ADDENDUM NO. 1

GROVE USA, LLC.  
PAINT SHOP ALTERATIONS & OUTDOOR PAINT BUILDING  
CONTRACTS NO. 24044-A GENERAL CONSTRUCTION  
JULY 19, 2024

GROVE USA, LLC  
 PAINT SHOP ALTERATIONS & OUTDOOR PAINT BUILDING  
 SHADY GROVE, PENNSYLVANIA

3-A4.1

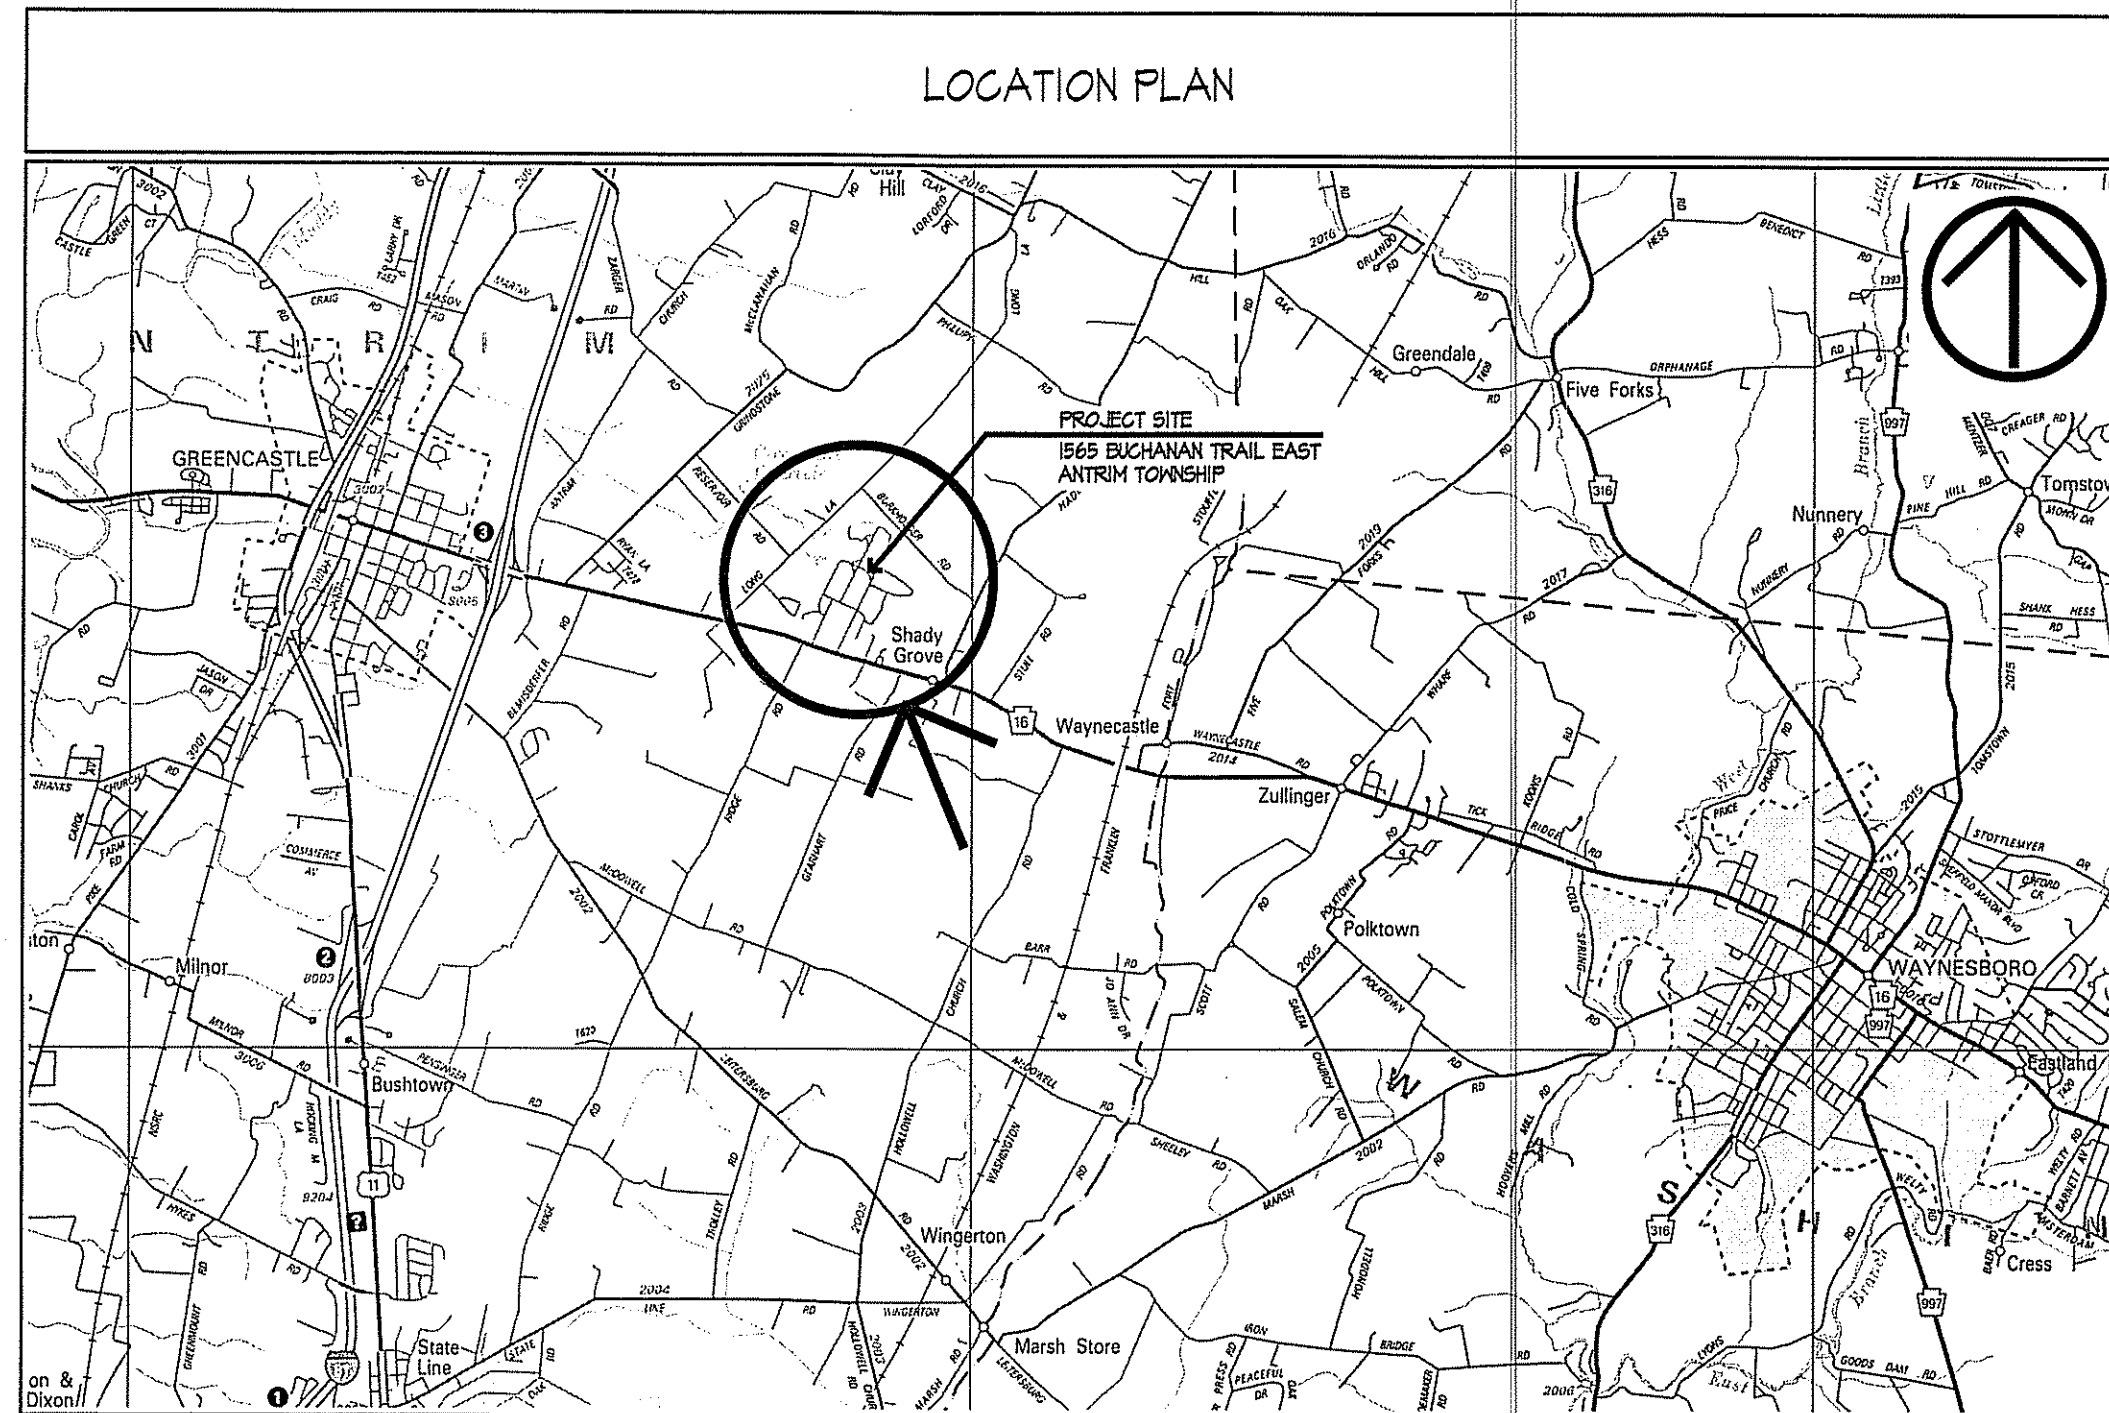
22. The gas line pressure is 30 psi and shall be welded.
23. A revised Detail 3 shown on Drawing A4.1 is attached with additional information on the fire partition wall associated with the stair walls and ceilings.

X1.1

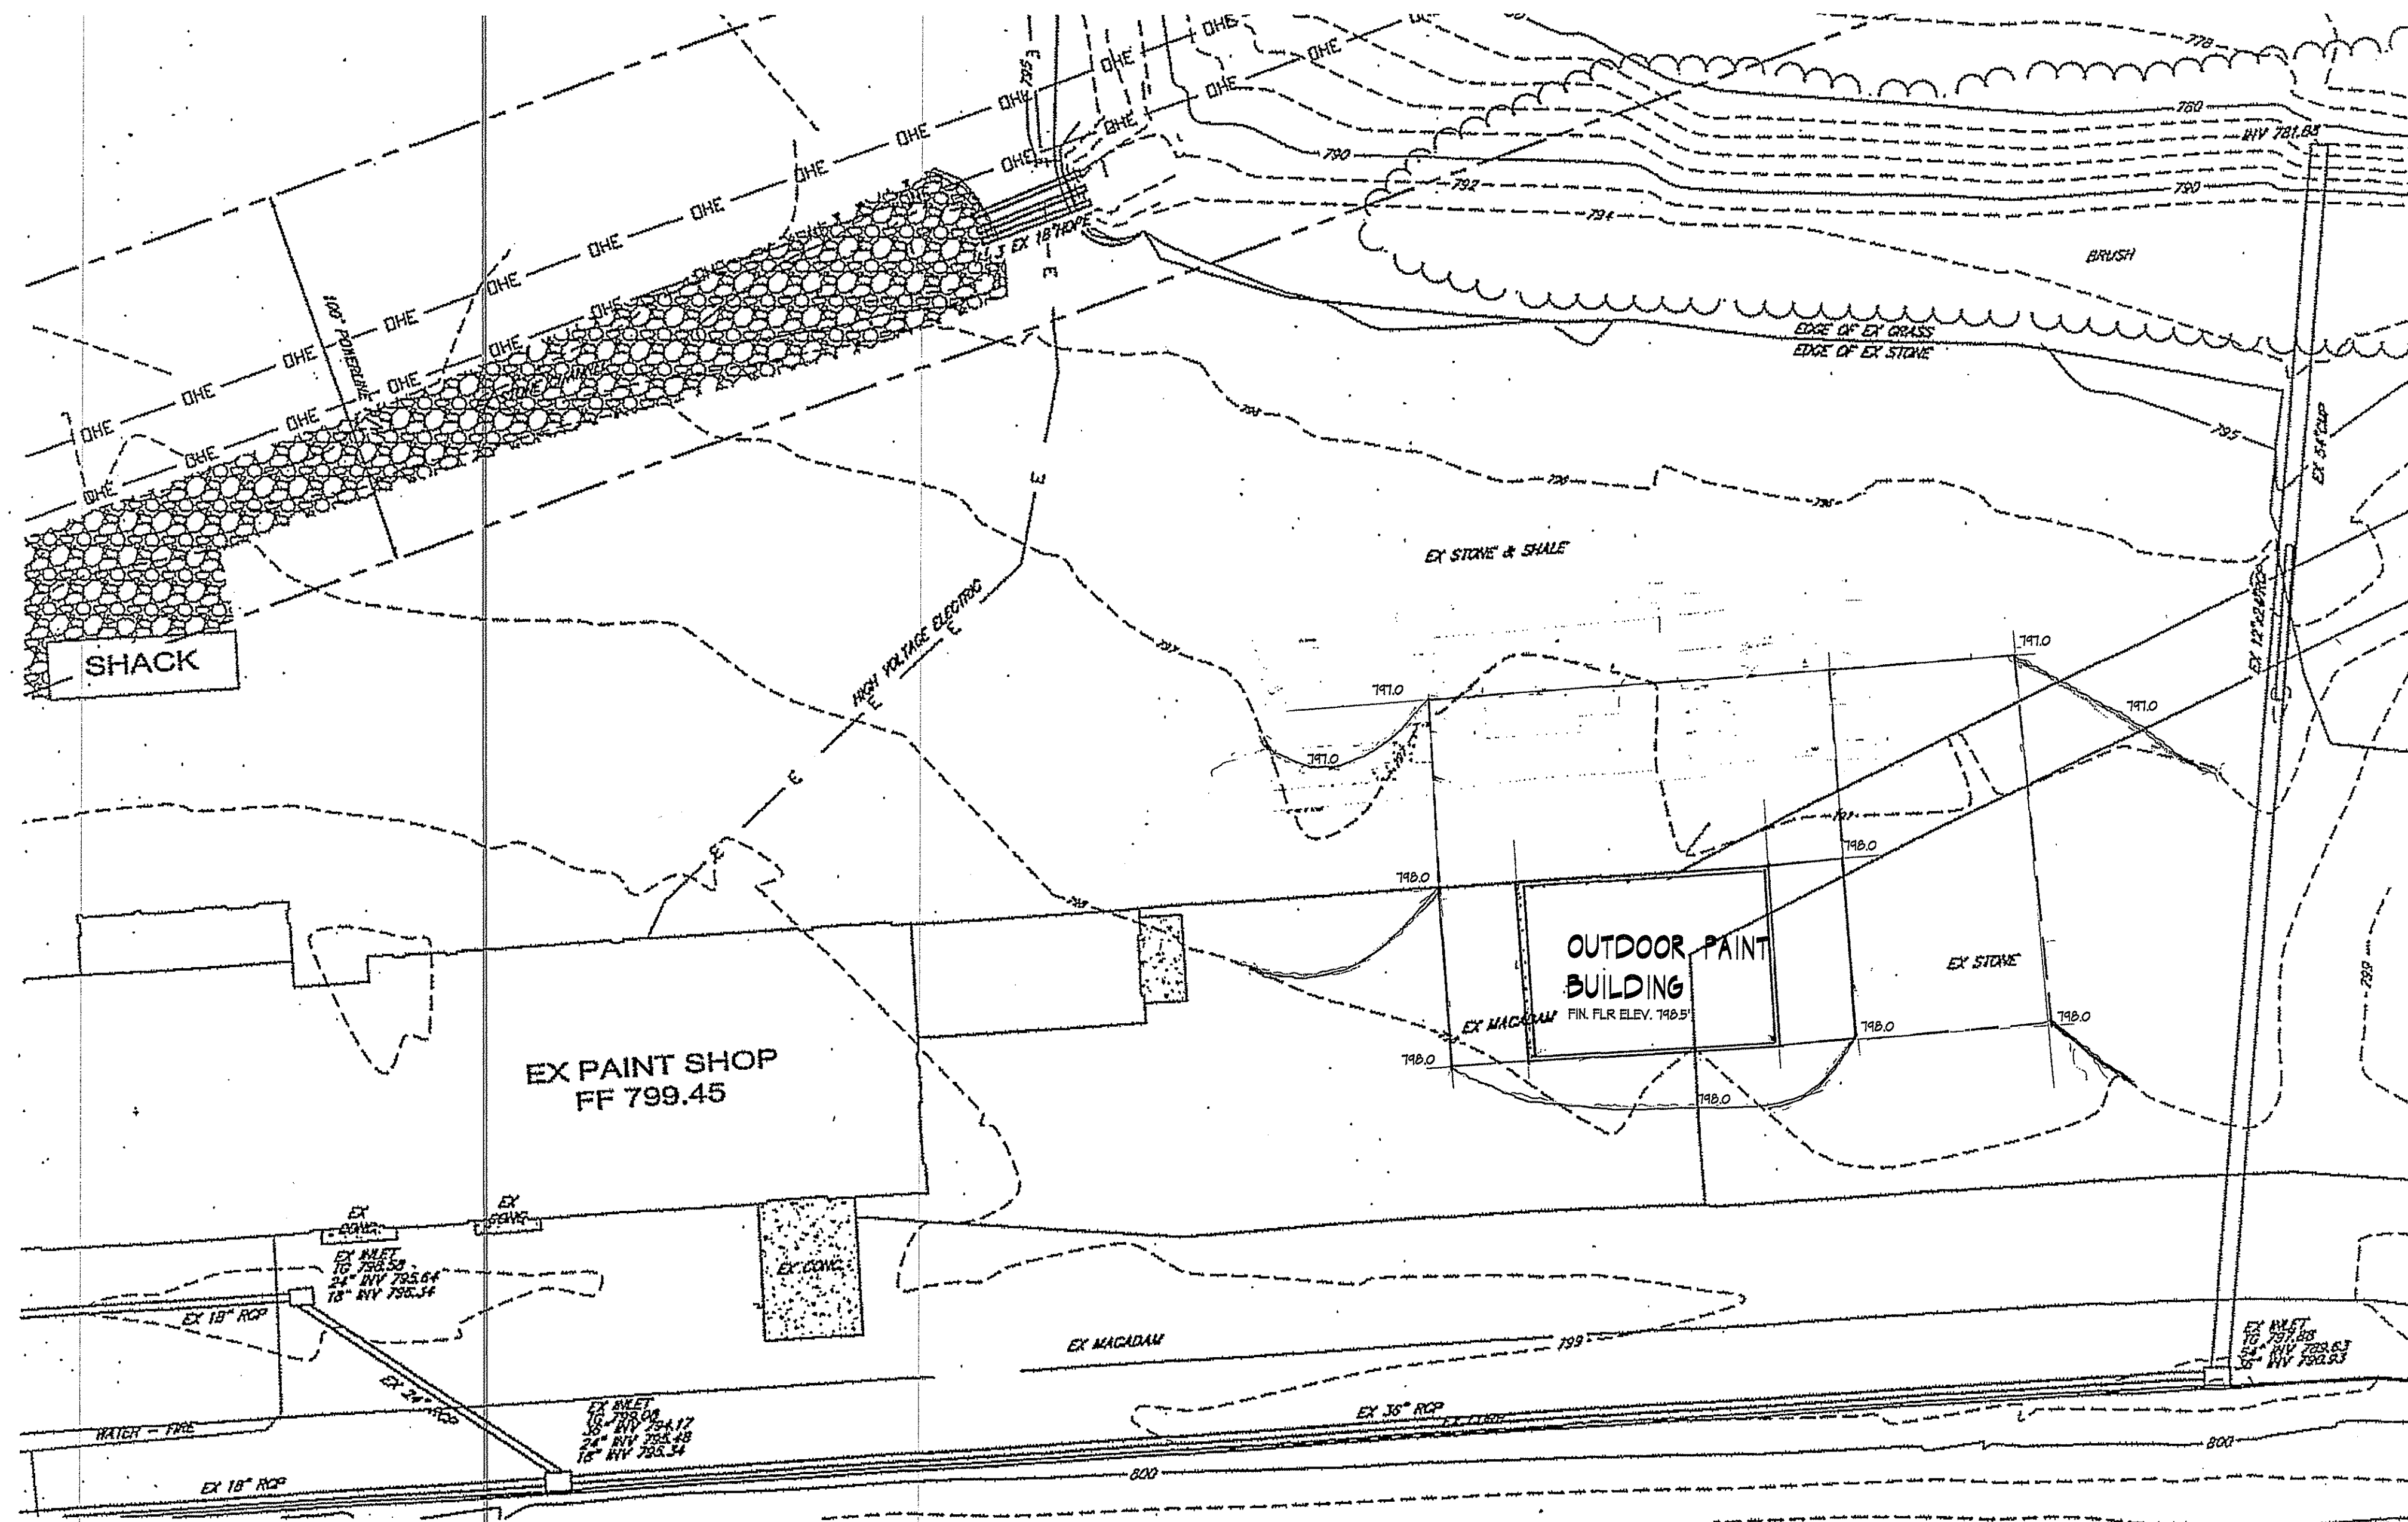
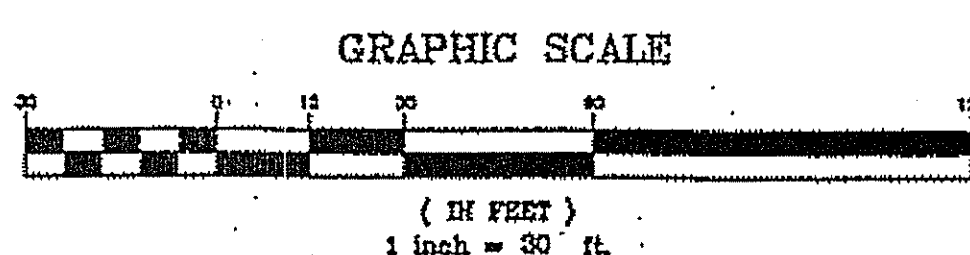
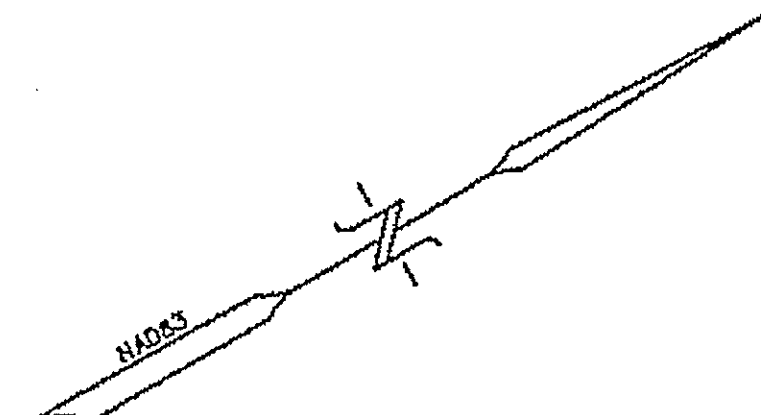
9. A revised drawing X1.1 is issued illustrating the finish floor elevation for the Outdoor Paint Building and perimeter grading. All disturbed areas surrounding the building shall be graded to drain and restored to match existing subgrade.
